URBAN PLANNING DELEGATED COMMITTEE

3.1 69 Broadway, Camberwell (Partial demolition and construction of alterations and additions associated with a dwelling in a Heritage Overlay)

Application no.: PP22/0734

PLANNING ASSESSMENT Urban Planning Delegated Committee

Above - Demolition Plan, areas proposed for demolition shown in red

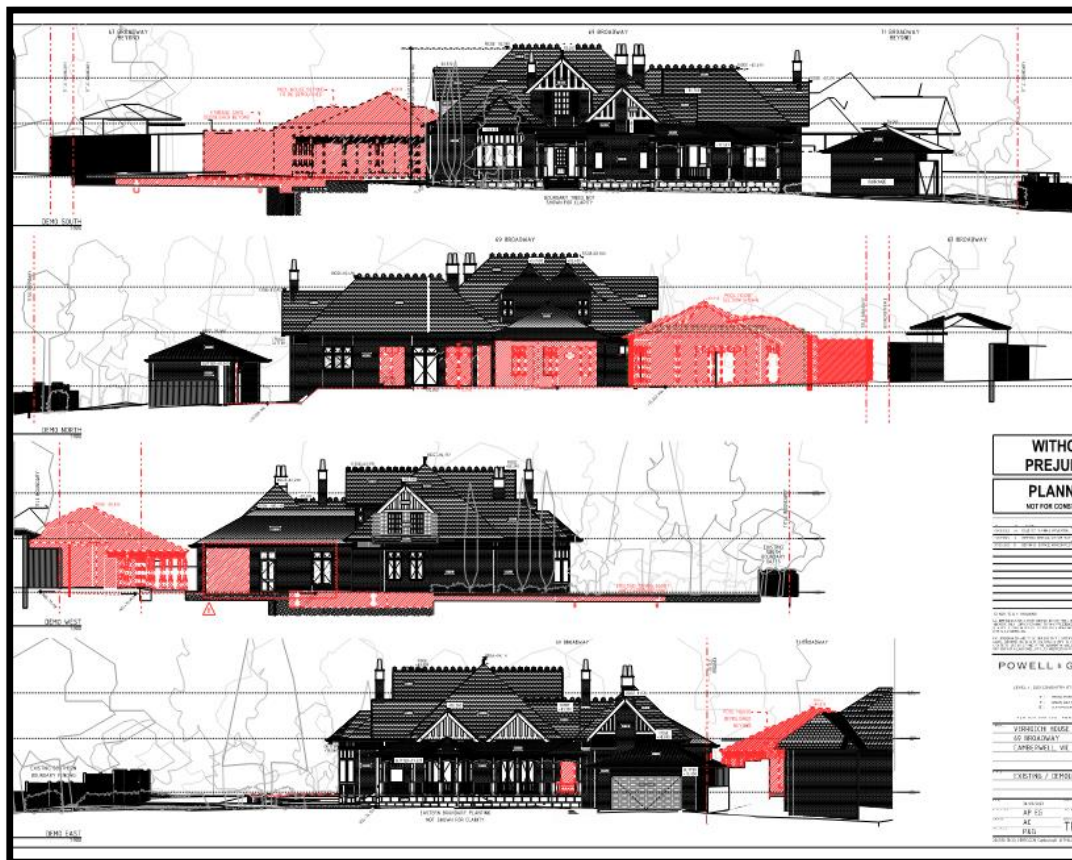
2. *The extent of proposed demolition be limited to the portions shown at points 5, 6 and 7 (below the eaves) in the annotated ground floor demolition plan at Figure 1.*

It is noted that the ground floor demolition plan isn't specific regarding the retention of the eaves around the building. A condition will be imposed on any planning permit issued that specifies the retention of the eaves.

In light of the above analysis and guidance, it is recommended that the extent of proposed demolition be limited to points 5, 6 and 7 shown at Figure 1 above, as the minimum required to reasonably accommodate a connection between the original fabric and new development at the point of minimum impact to potentially original features—that is, at a point that will not affect the cultural significance of the place. It is further recommended however that demolition be to the below eaves portions only and that demolition of the eaves and roof form (shown as number 8 on Figure 2 above) be removed from the proposal, as there is no evidence that this original (and significant) fabric has been altered. It is assessed that this extent of demolition would not adversely affect the significance of the place, and allow an addition that may enable long term continuing use of the building otherwise completely intact and thus encourage its conservation.

- a. Correction of the demolition floor plan to show the retention of the eaves on the main dwelling building.
 - b. Provide structural engineering advice and methodology on how the chimney above the Dining/Living 2 rooms will be supported within the roof space to allow the demolition of the fireplace.

- Correction of the proposed demolition floor plan to show the retention of the eaves for the dwelling.
- Provide structural engineering advice and methodology on how the chimney above the Dining/Living 2 rooms will be supported within the roof space to allow the demolition of the fireplace.

Above - West Elevation - Lightweight pergola structure, shown in yellow and living room shown in green above

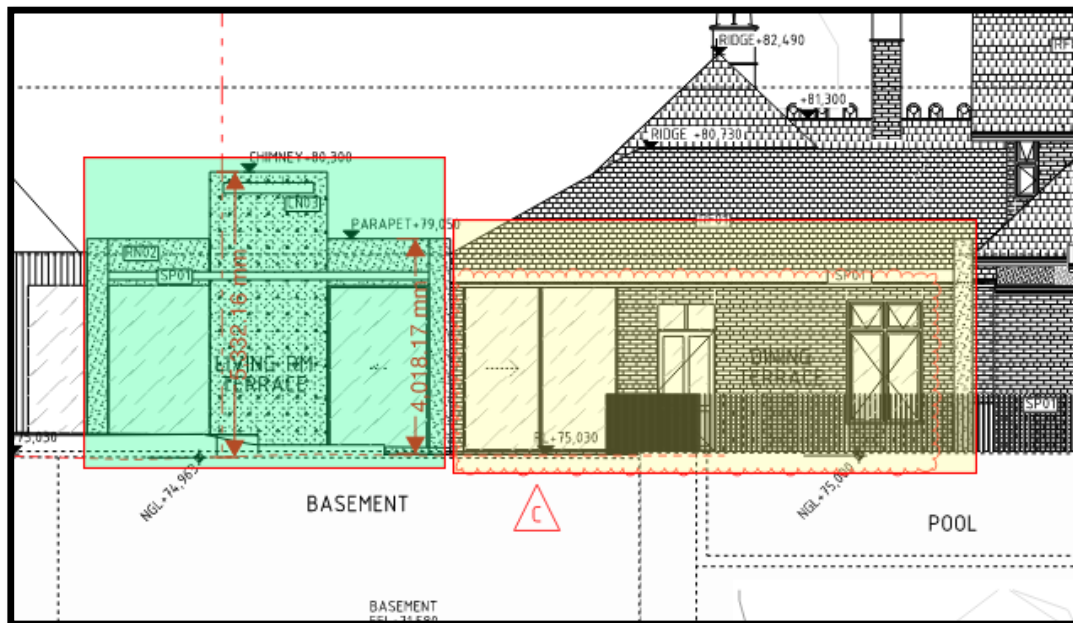
Council's Heritage Advisor, as part of their written referral, required that the pergola be a lightweight structure. During the review of the Discussion Plans and meeting, the pergola was identified as being structurally independent of the main dwelling. A condition will be placed on the permit to ensure this.

The proposed terraced area to the west is supported, subject to the recommendation that any alfresco area in this location retain the original openings to the building (as recommended above) and replace the proposed steel pergola (which from the roof plan appears to have an awning) for a more lightweight shading option that minimises intervention in, and ideally is independent from, the original built fabric.

- e. Provide additional details, either sectional plan or similar, demonstrating that the lightweight pergola is structurally independent from and sits below the eaves of the host dwelling.

- Provide additional details, either sectional plan or similar, demonstrating that the lightweight pergola is structurally independent from and sits below the eaves of the host dwelling.

Above - Material Schedule

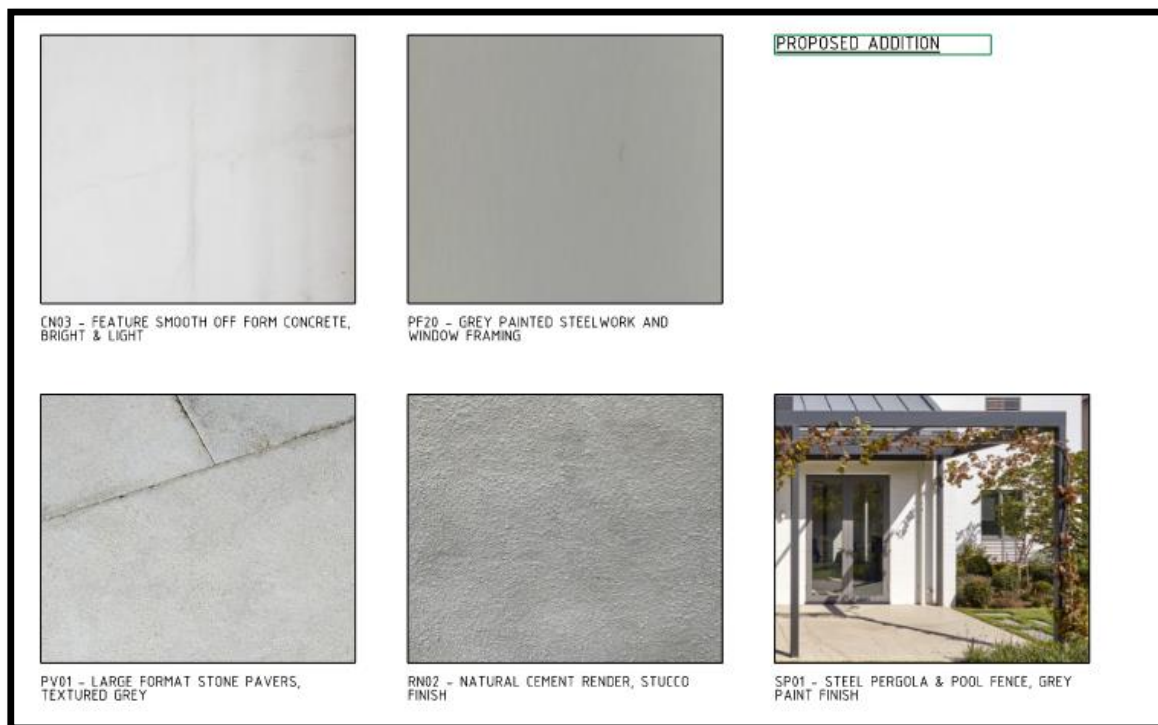
Council's Heritage Advisor noted that the surface treatment to the basement entry was to be concrete aggregate, to match existing. This detail was taken from the HIS and Landscape Plan. Council will provide the following condition to ensure this surface treatment is provided on the final endorsed set.

- f. Provide the basement entry surface finish as concrete aggregate and update the material schedule.

- Provide the basement entry surface finish as concrete aggregate and update the material schedule.
